Duke Power  
Catawba Nuclear Station  
4800 Concord Road / CN01VP  
York, SC 29745-9635

Subject: Duke Energy Corporation  
Catawba Nuclear Station, Units 1 and 2  
Docket Numbers 50-413 and 50-414  
Proposed Technical Specification Amendment  
Technical Specification 3.7.16, Spent Fuel  
Assembly Storage, and 4.3, Fuel Storage

**MARKUP of TECHNICAL SPECIFICATIONS PAGES FOR CATAWBA**

DELETE THIS TABLE

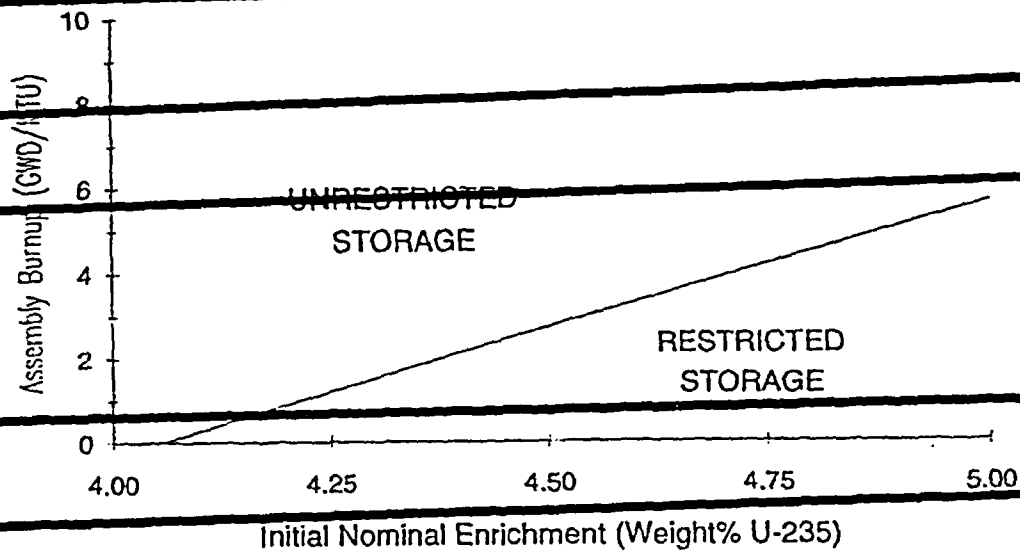
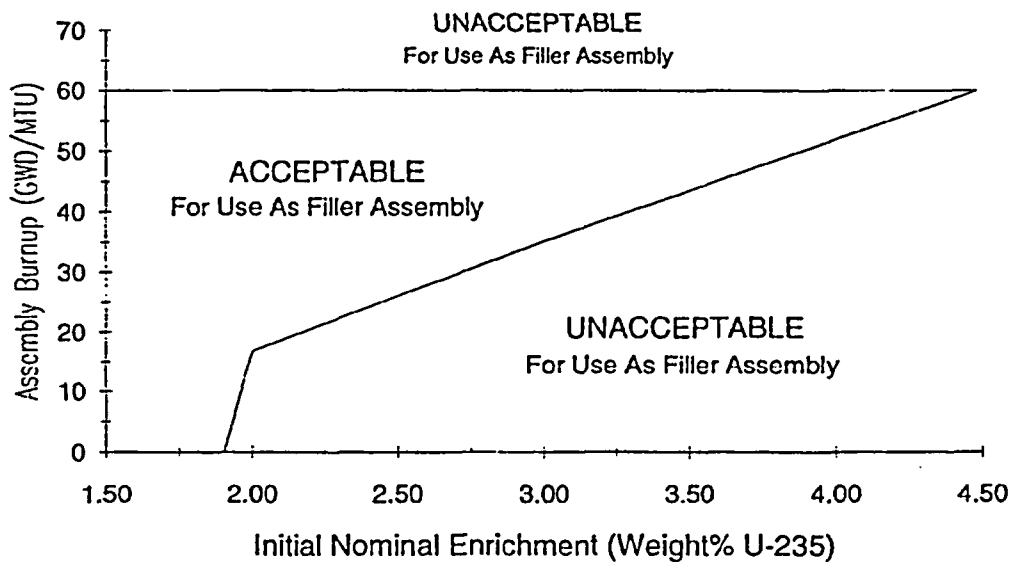
- **Table 3.7.16-1:** As discussed above, this table is deleted. The revised criticality analysis described in Attachment 4 removes any burnup requirements from Unrestricted storage of LEU fuel.

Figure 3.7.16-1  
Required 3 out of 4 Loading Pattern for Restricted Storage

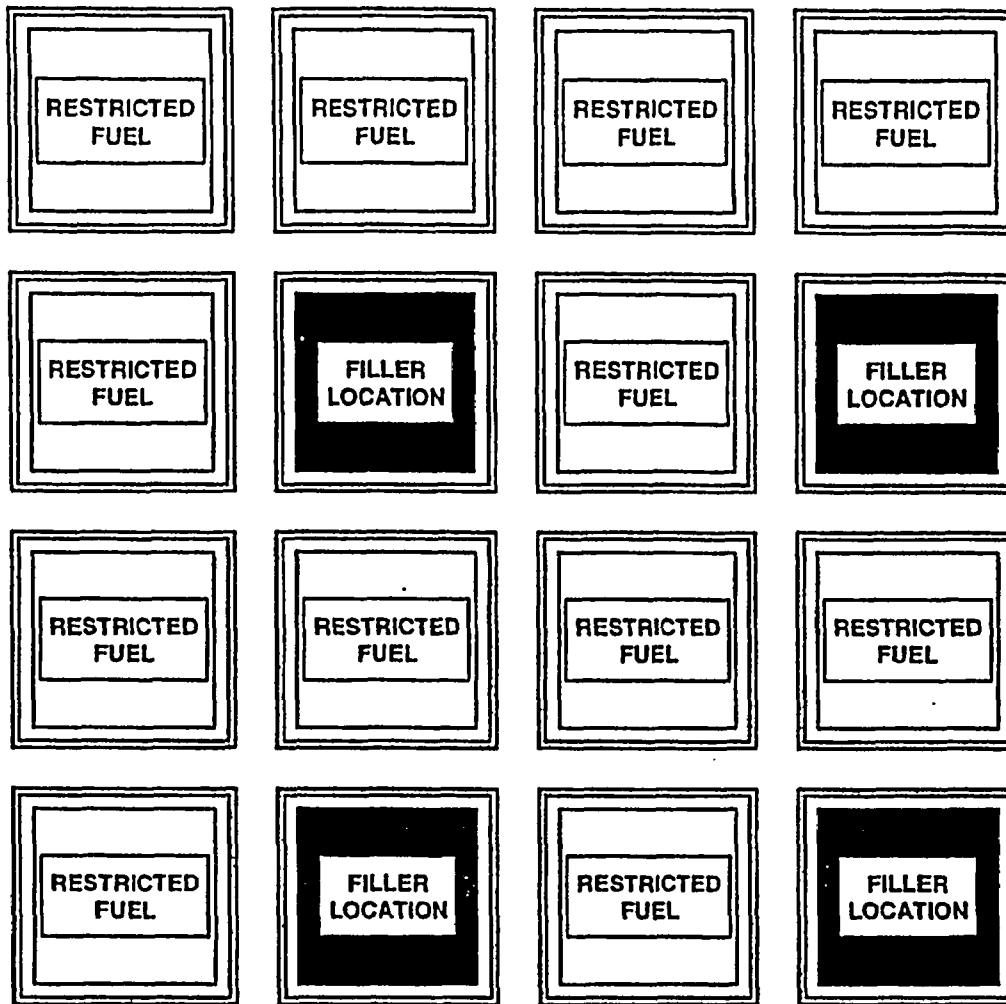
- **Figure 3.7.16-1:** This figure illustrates the loading configuration for Restricted / Filler fuel storage in the Catawba SFPs. The definition of Restricted fuel is revised on this figure, to remove the reference to current TS Table 3.7.16-1. As noted above, the revised Catawba SFP criticality analysis eliminates the need to store any LEU fuel as Restricted fuel.

Any row bounded by an Unrestricted Storage Area shall contain a combination of ~~restricted fuel assemblies and filler locations~~ arranged such that no ~~restricted fuel assemblies~~ are adjacent to each other. Example: In the figure above, row 1 or column 1 can not be adjacent to an Unrestricted Storage Area, but row 4 or column 4 can be.
